STAFF RECOMMENDATION

1227 Fifth Ave North

October 19, 2016

Application: New construction- outbuilding; Setback determination

Figure 1: 1227 Fifth Avenue North

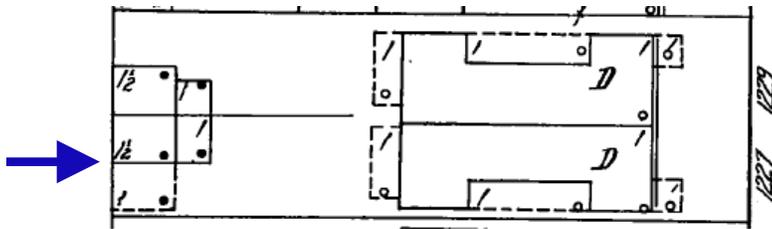
Background: The house located at 1227 Fifth Avenue North is a single-story, zero-lot line dwelling that was constructed c. 1899 (Figure 1). The house contributes to the historic character of the Germantown Historic Preservation Zoning Overlay.

Figure 2: 1914 Sanborn map

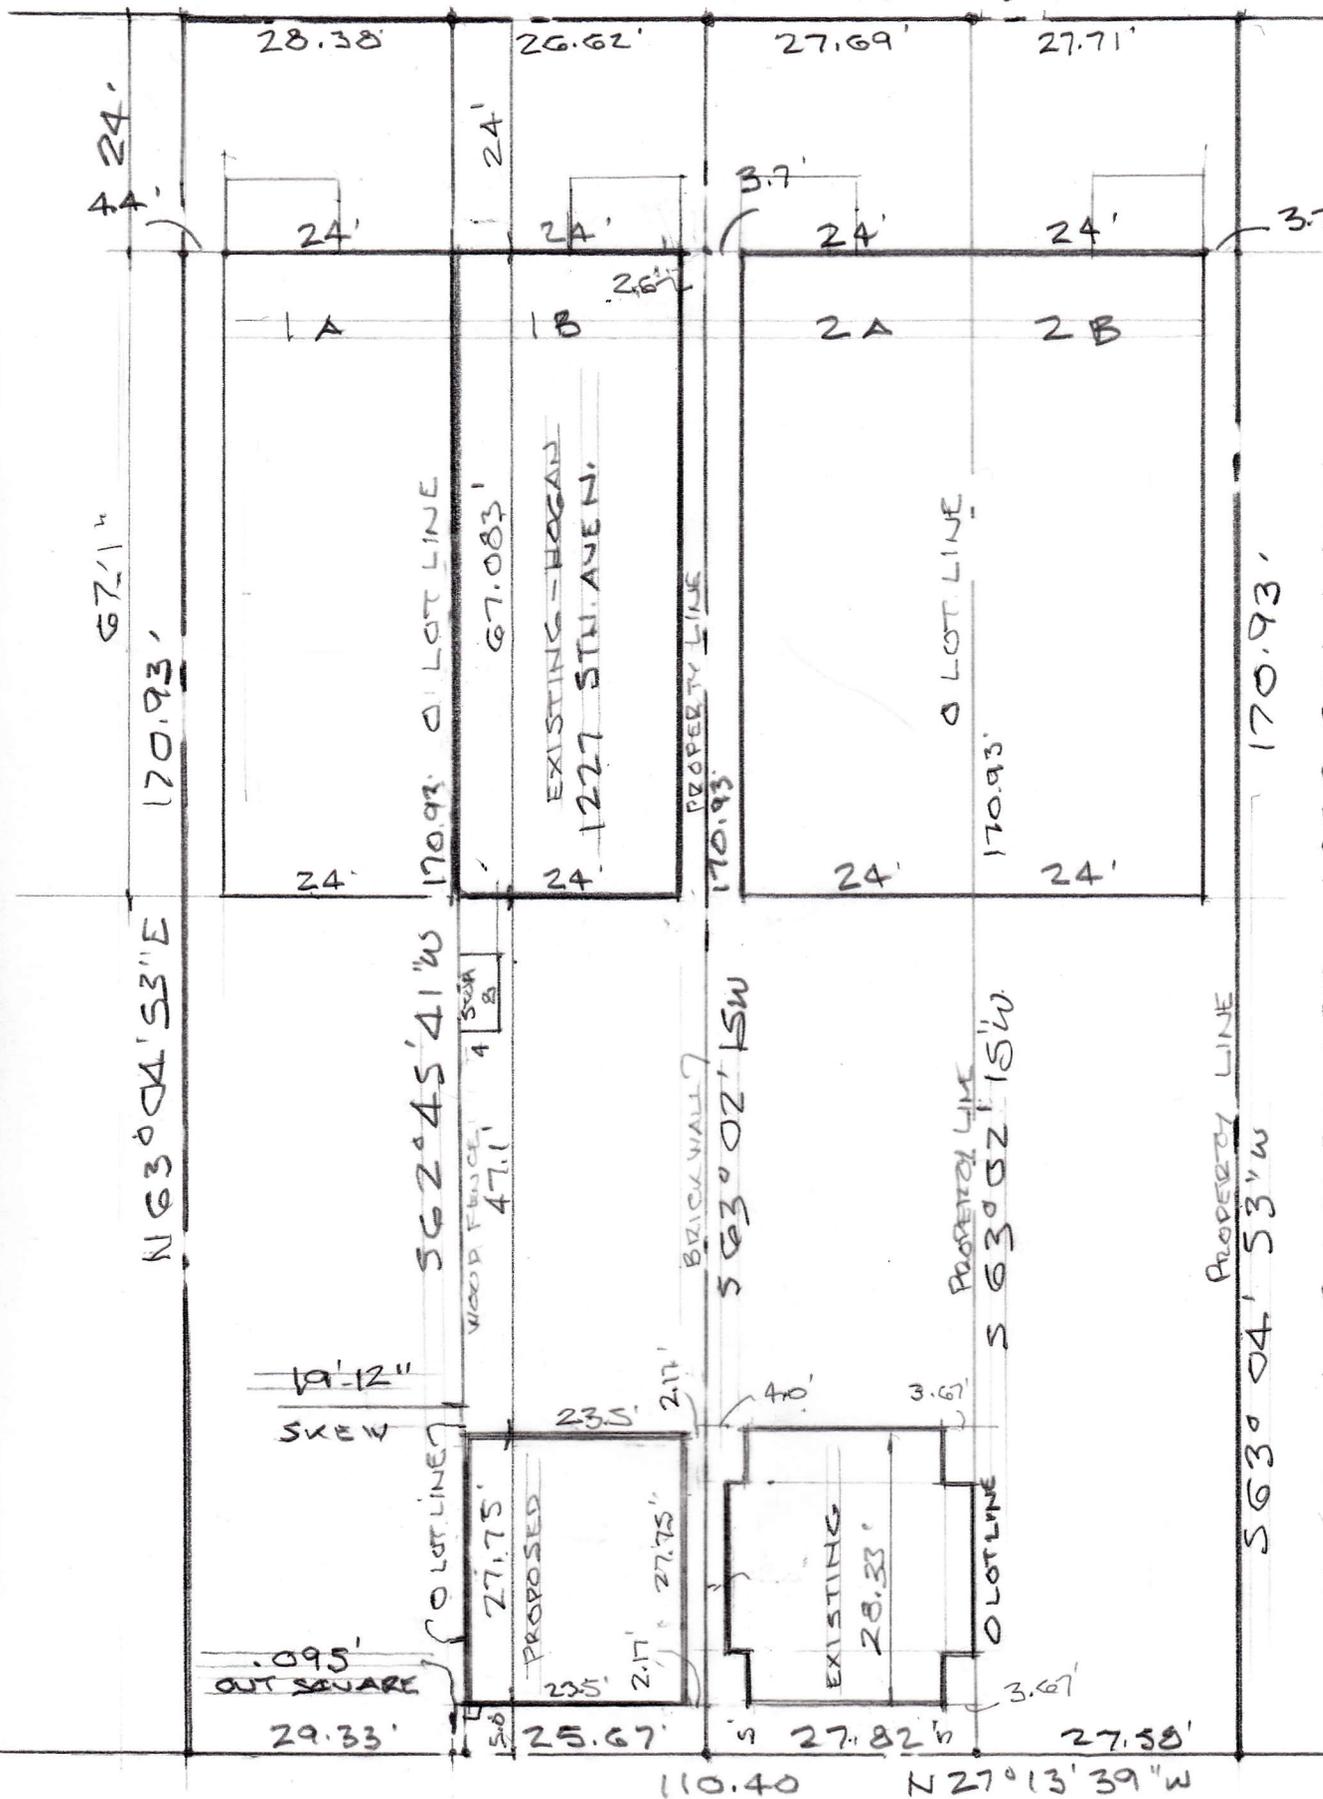
Location, Setback: The proposed structure is located in the rear yard of the property with its garage doors facing the alley, as is typical for outbuildings in Germantown. The location of the structure does not meet the base zoning requirements for the rear setback. The bulk standards for MUN allow for zero foot side setback and requires a twenty feet (20') rear setback. As proposed, the structure has a five feet (5') rear setback, zero foot (0') right side setback, and two feet, two inches (2'-2") left side setback. Staff finds that

the proposed setback determination is appropriate in this instance since the 1914 Sanborn map shows that this property once had a rear outbuilding that was located on the rear property line (Figure 2).

Staff finds the location and setbacks of the proposed outbuilding to meet Sections 2.9.2. and 2.9.3. of the *Germantown Historic Overlay Design Guidelines*.

ELEVATIONS 1/8" = 1'-0" FOR 11" x 17" SHEET

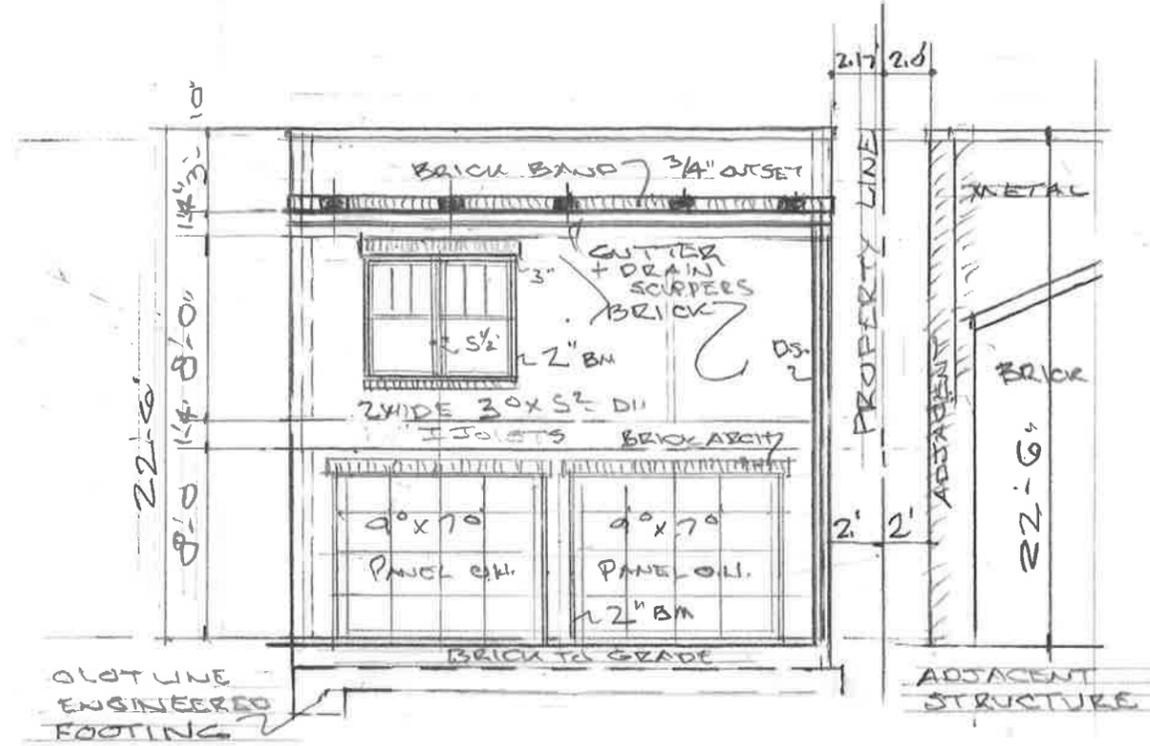
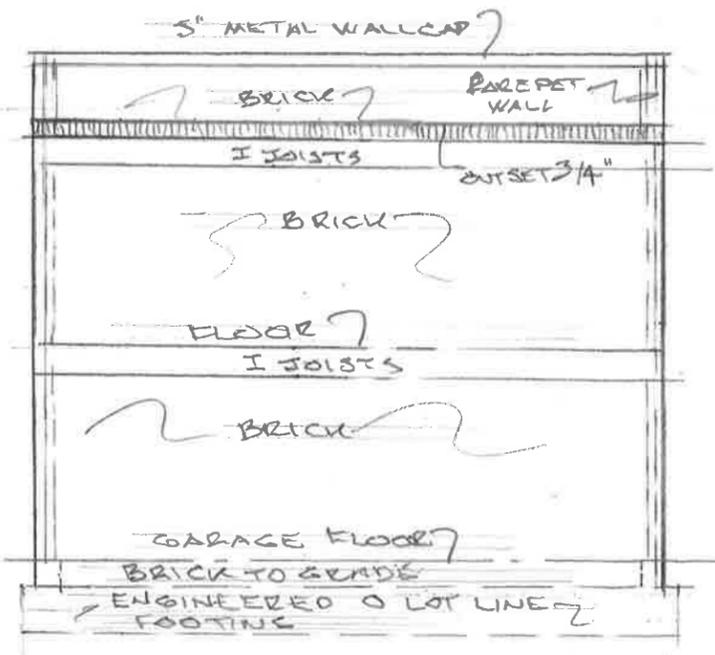
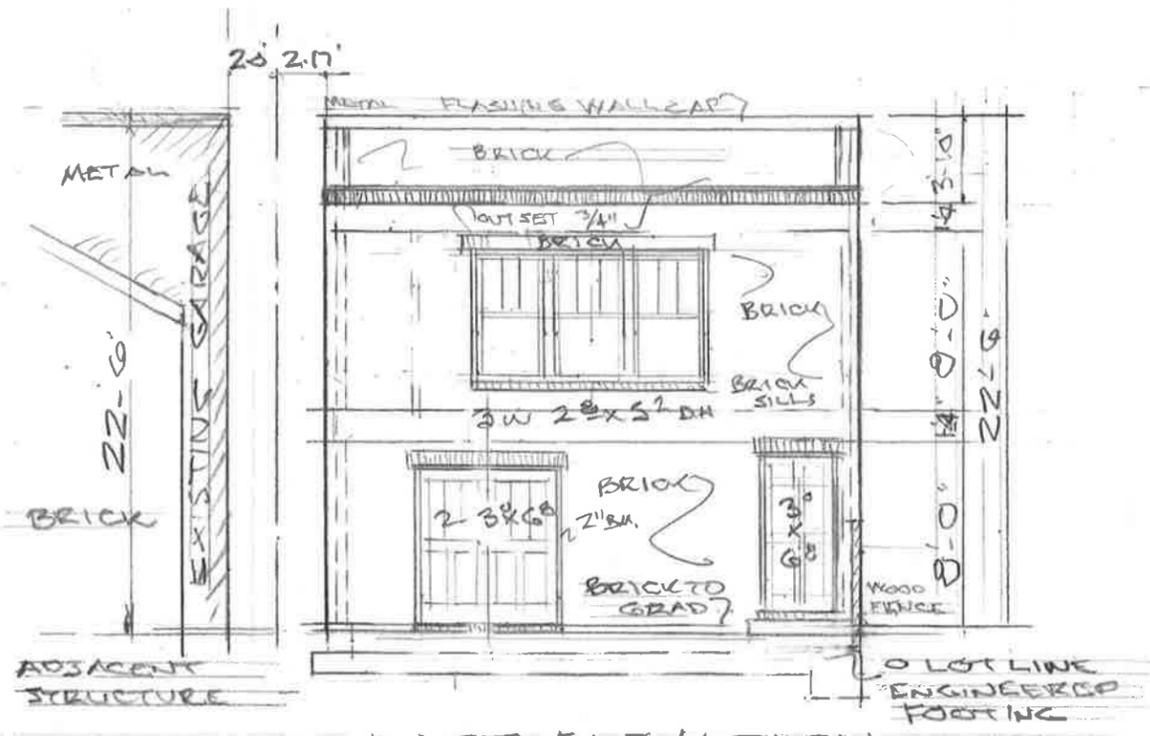
Height, Scale: The existing single-story house has a ridge height of twenty-five feet (25'). The proposed structure is two stories, but is shorter than the existing house at twenty-two feet, six inches (22'6"). Staff finds a two-story structure behind a one-story historic structure is appropriate in this case because the Germantown neighborhood is diverse, with many utilitarian and industrial structures of two or more stories. In addition, the 1914 Sanborn map shows that on this site there was a one-and-a-half story accessory structure, which although less than two stories, was still larger in terms of number of floors than the historic house (Figure 2). Lastly, staff finds the two-story accessory structure appropriate because it is two feet, six inches (2'6") lower in height than the historic house.

The outbuilding will be twenty-three feet, six inches (23'-6") wide. By contrast the historic house is approximately twenty-four feet (24') wide. The proposed footprint of the outbuilding is six hundred and fifty-two square feet (652 sq. ft.) compared to the footprint of the historic house which is approximately one thousand six hundred and ten square feet (1610 sq. ft.). Therefore, the proposed structure will not be wider than the historic house and will have a footprint that is less than half the footprint of the primary structure.

Materials, Texture, and Details and Material Color: The proposed outbuilding will have a concrete slab foundation with brick as the primary cladding material. Staff finds that the proposed materials are appropriate as they are common within the district.

The materials for the windows, doors, garage doors, and roofing are unknown. Staff finds, that with conditions that staff approve the final roof, windows, doors, and garage door selections as well as the color and texture of the masonry prior to purchase and installation, the proposed outbuilding can meet Section 2.9.1. of the *Germantown Historic Overlay Design Guidelines*.

Roof and Building Form: The outbuilding will have a flat roof form which is characteristic of industrial/utilitarian structures that are seen throughout the neighborhood. Staff finds the flat form to be appropriate at this location because similar industrial influences are seen frequently on modern outbuildings and multi-family structures. In addition, the design of this building will not be disruptive to the historic character of the house and the district because it is neither taller nor wider than the historic house and will not be visible from the street.

Proportion and Rhythm of Openings: The windows on the proposed outbuilding meet the historic proportion of openings, which are generally twice as tall as they are wide. In addition, the garage doors will face the alley as is appropriate. No changes are proposed to the openings of the historic house. Staff finds the outbuilding's proportion and rhythm of openings to meet Section 2.9.5. of the *Germantown Historic Overlay Design Guidelines*.

Recommendation: Staff recommends approval of the application with the following conditions:

1. Staff approve the final roof , windows, doors, and garage door selections as well as the color and texture of the masonry prior to purchase and installation; and
2. The HVAC be located behind the house or on either side, beyond the mid-point of the house.
